**STAFF RECOMMENDATION**

**1605 Forrest Avenue**

**May 21, 2014**

**Application:** New construction - infill

ARCHITECTURAL SITE PLAN

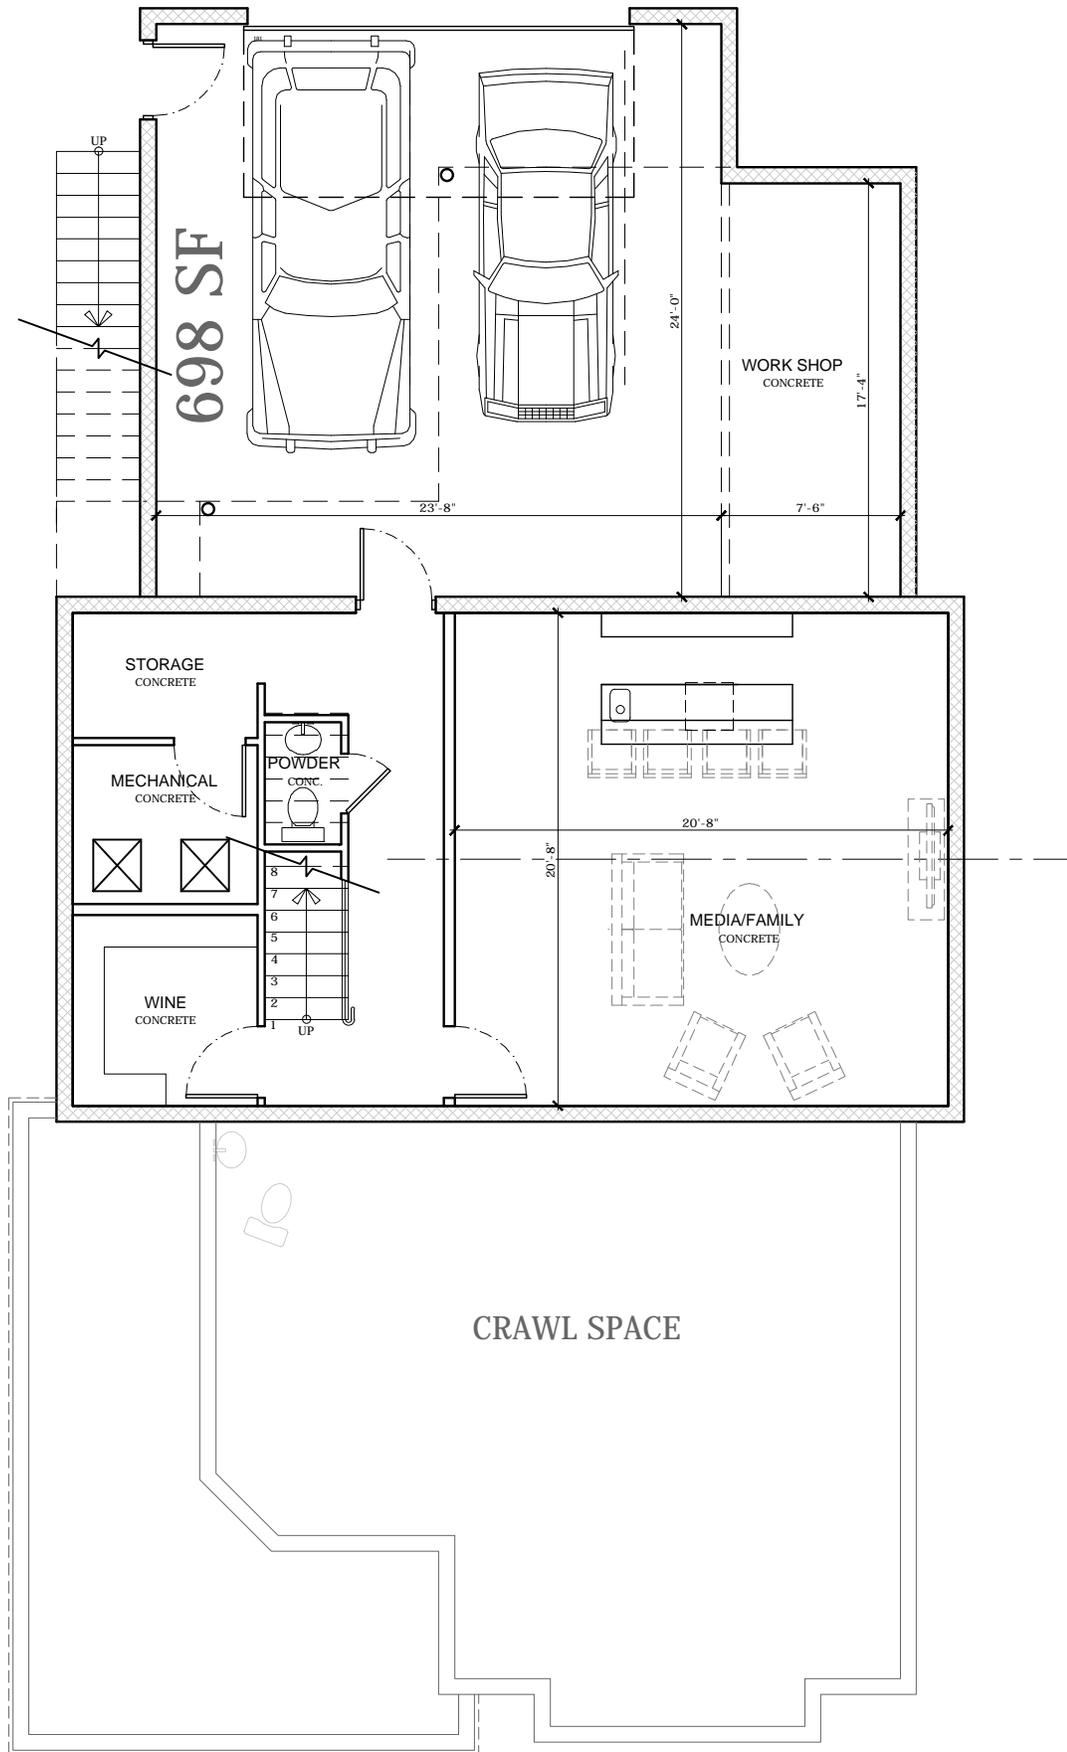
The front setback of the new house will be twenty feet (20'). Staff recommends as a condition of approval that the new house align with the adjacent historic house to the right, approximately twenty-three feet (23'). The building to the left faces South Sixteenth Street and is not historic. The new house will have side setbacks of seven feet (7') on the left and five feet (5') on the right. Because the form of the house is asymmetrical, the setbacks will appear greater at the front of the house, helping to maintain the rhythm of spacing established by historic houses on the street.

With the front setback increased so that the building aligns with the adjacent house to the right, Staff finds that the project will meet guideline II.B.3.

- The front setback is increased to align with the adjacent house to the right.
- Staff approves the brick, windows, and doors prior to selection.
- Staff approves the material of the front walkway and rear driveway.

FRONT ELEVATION

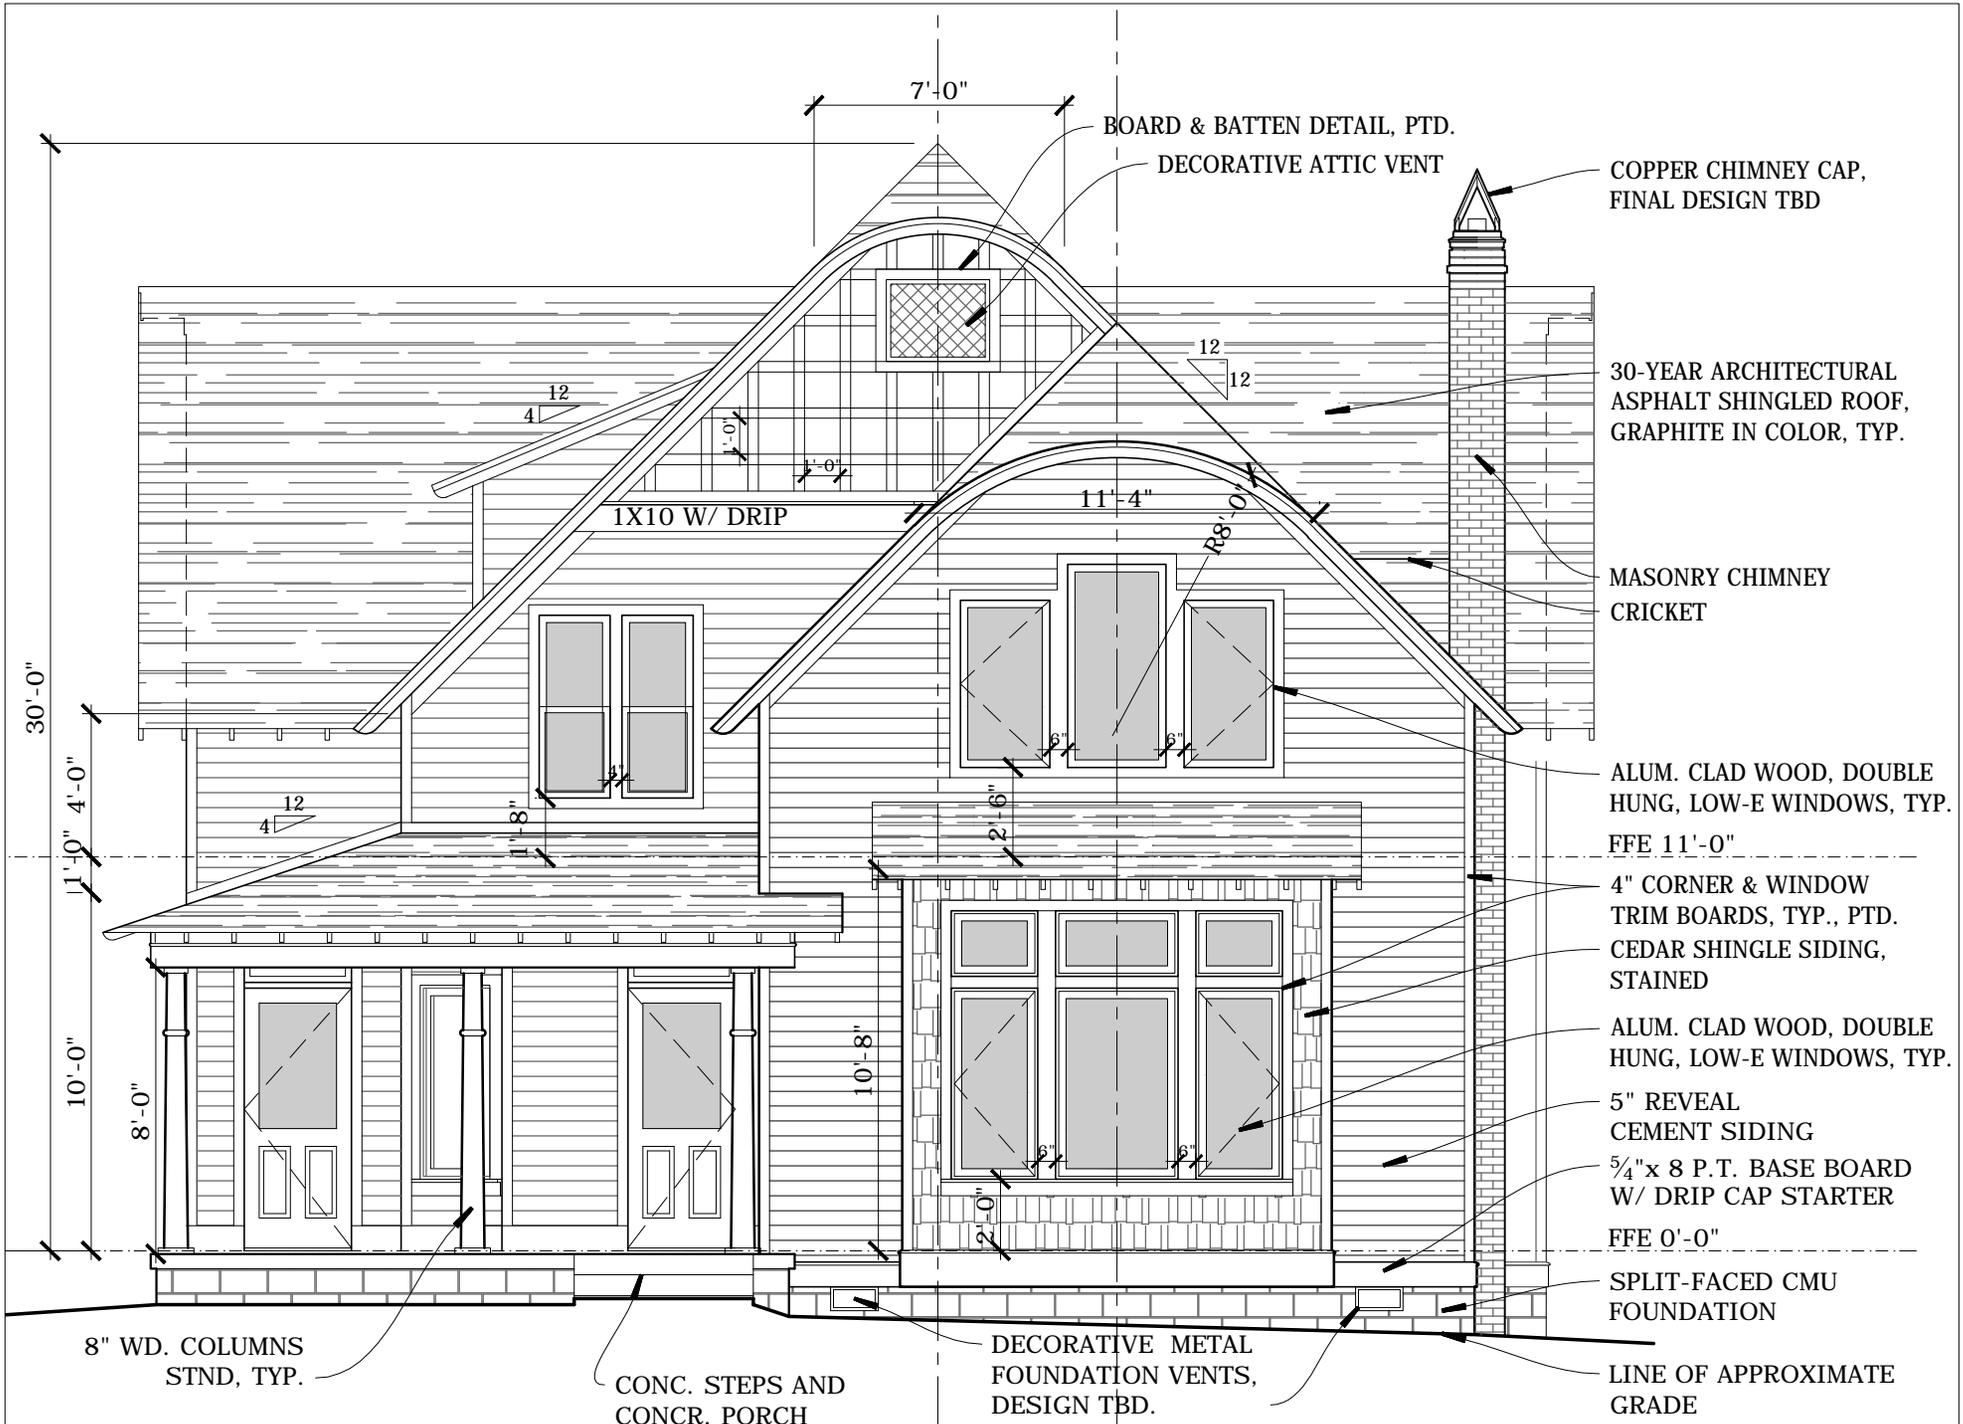
The new house will be one and one-half stories tall. Although contemporary in its composition and ornamentation, the form of the new house will be similar to that of a Queen Anne house with a tall center “core” and smaller projections to the front and sides, and a wrap-around front porch. This form is common historic throughout the Lockeland Springs neighborhood.

The primary mass of the house will be thirty-feet (30’) wide and a clipped gable roof with a height of thirty-one feet (31’) above the floor level. This is comparable to historic houses in the area range between twenty-three feet (23’) and thirty-three feet (33’) in

The roofs of the new house will be gables with a pitch of 12:12. The front-facing gables will be clipped with arched rake ends, creating an effect similar to the decorative bargeboards that are common on Queen Anne houses. The front wrap-around porch will

The windows on the proposed new house are all generally twice as tall as they are wide, thereby meeting the historic proportions of openings. There are no large expanses of wall space without a window or door opening. Staff finds the project's proportion and rhythm of openings to meet Section II.B.7.
